Floodplain Development Permit and Riparian Alteration Application

Technical Narrative in Support of Floodplain Development Plan for 450 Wood River

CITY OF KETCHUM- FLOODPLAIN DEVELOPMENT PERMIT
450 WOOD RIVER

This memo provides additional information in response to a memo from Harmony Design and Engineering dated January 11, 2024, and in response to a comment letter from the City of Ketchum planning staff dated January 22, 2024, Floodplain Development Review Comments, Items #1 and #7.

CUT/FILL ANALYSIS - 450 WOOD RIVER

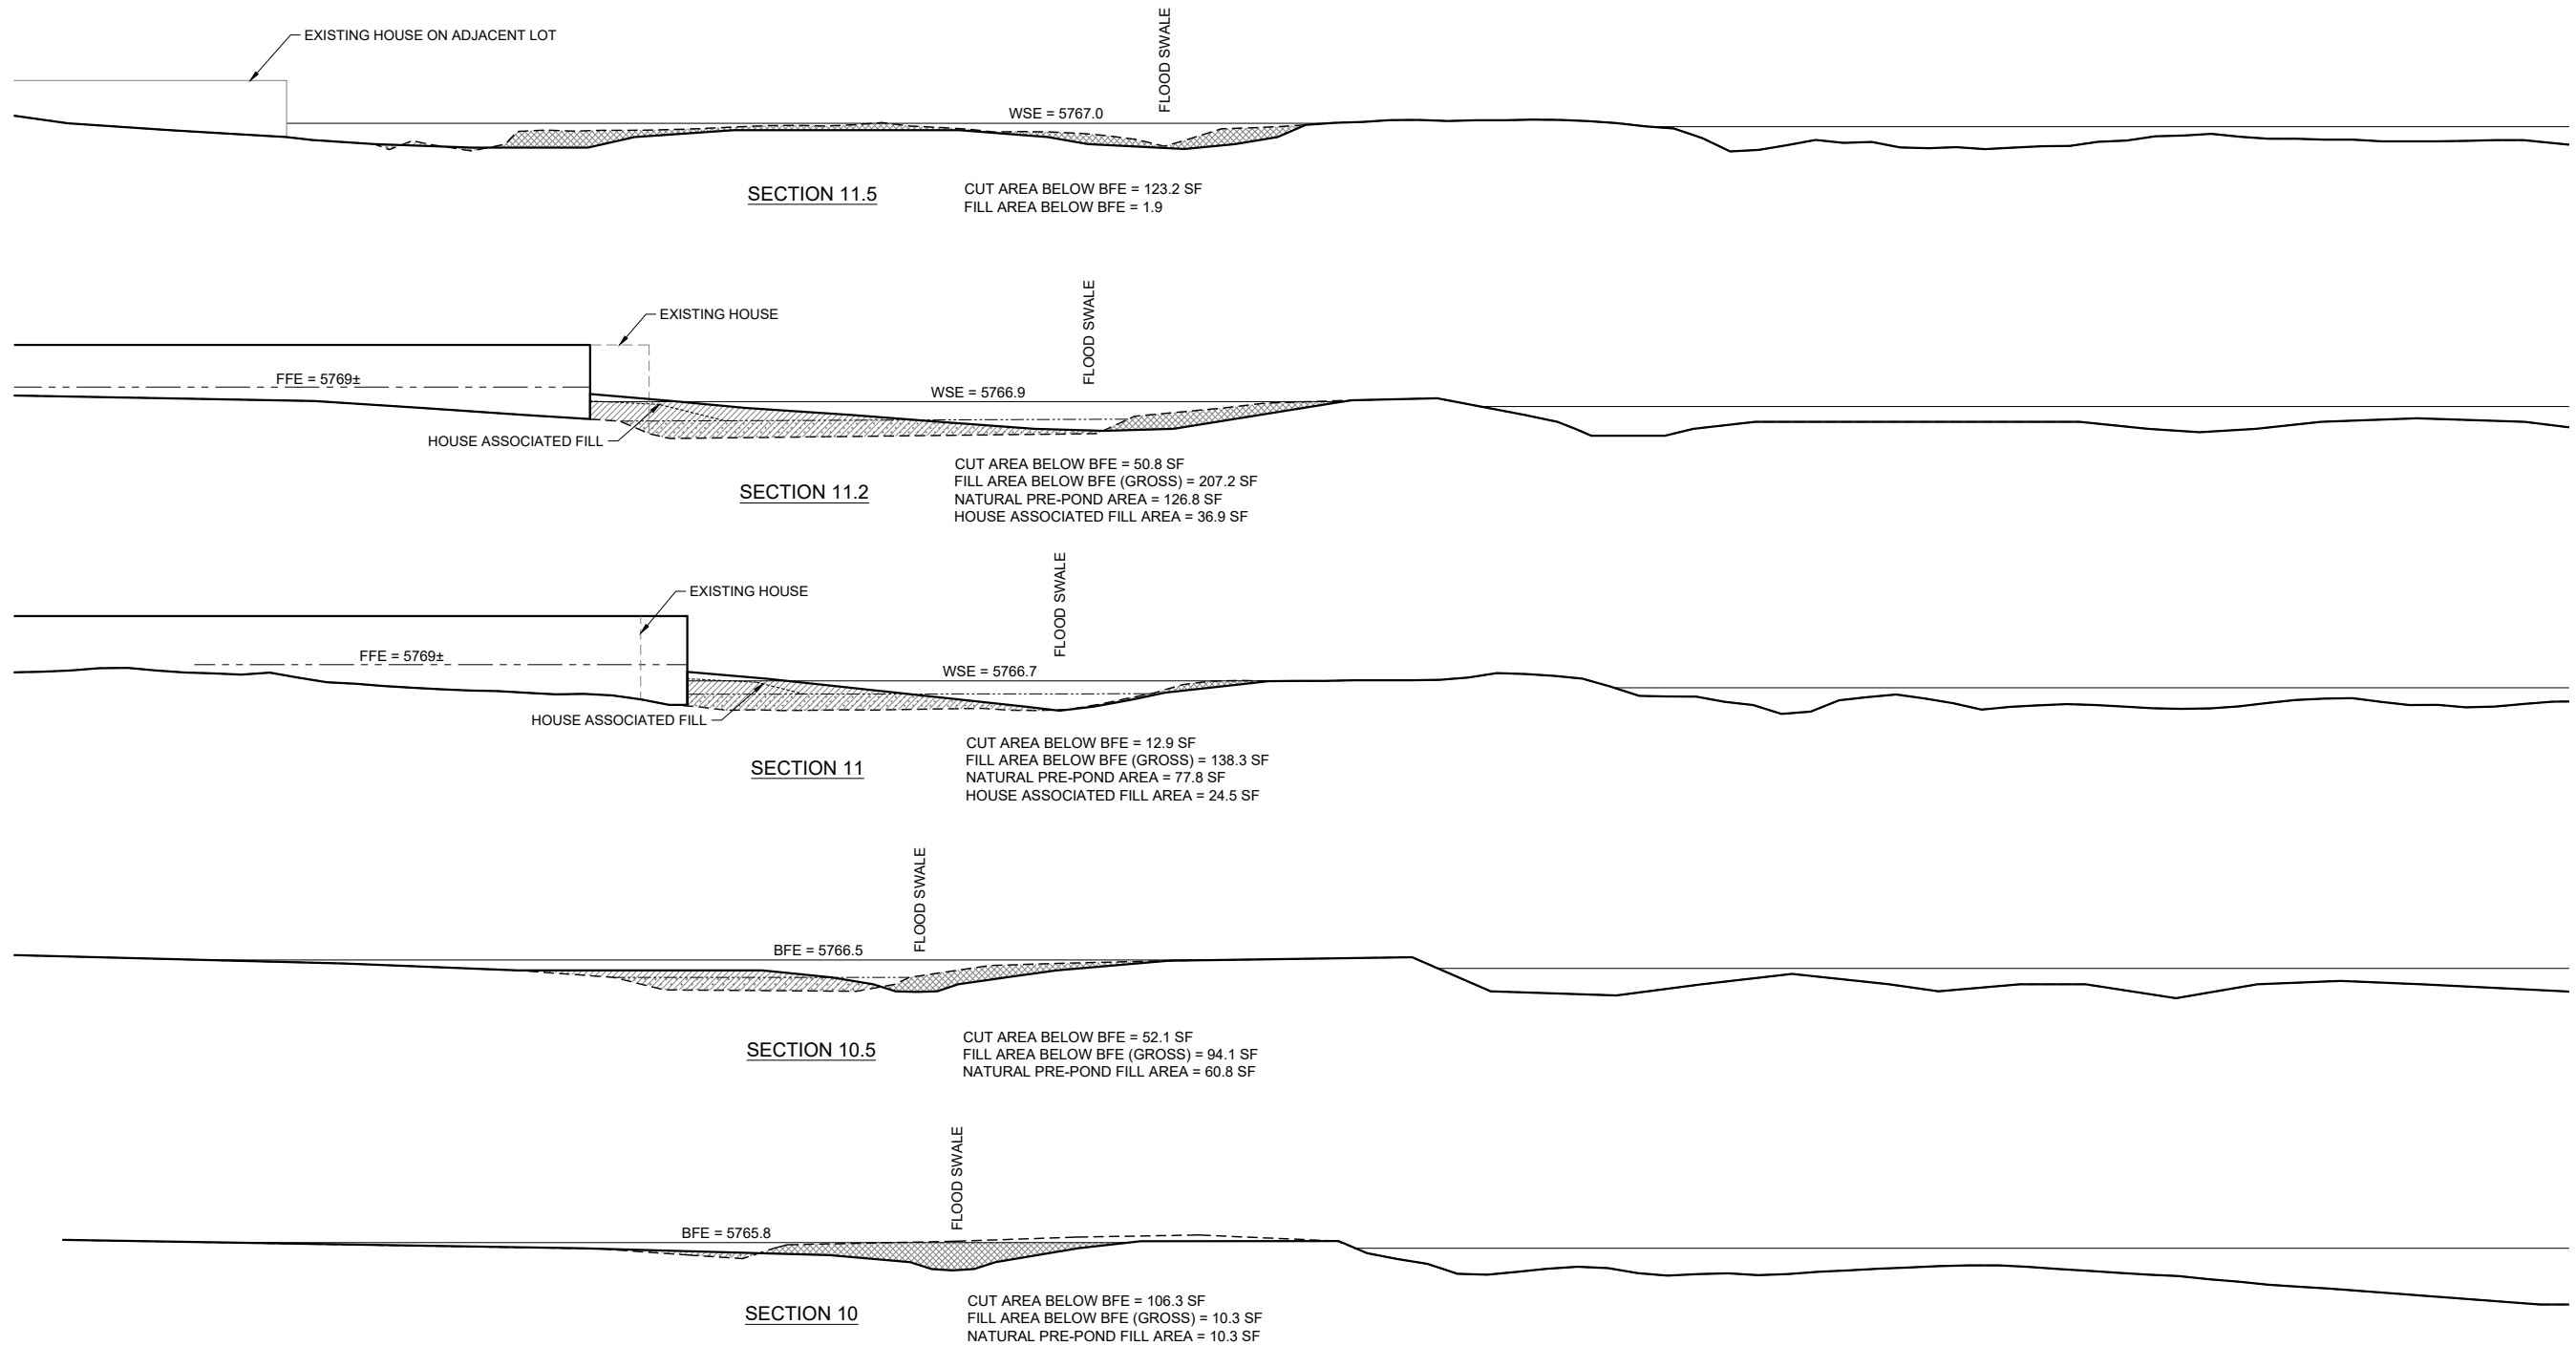
C. Response to planning staff letter, Floodplain Development Review Comments, Items #1 and #7

The compensatory storage analysis was recalculated based on the same methodology set forth in the August 15, 2023 memo, but using the higher water surface elevations calculated by the revised model and the revised grading plan developed to achieve a no-rise condition. The revised cross-sections and section areas are shown on the attached sheet, and Table 1 shows the revised calculation.
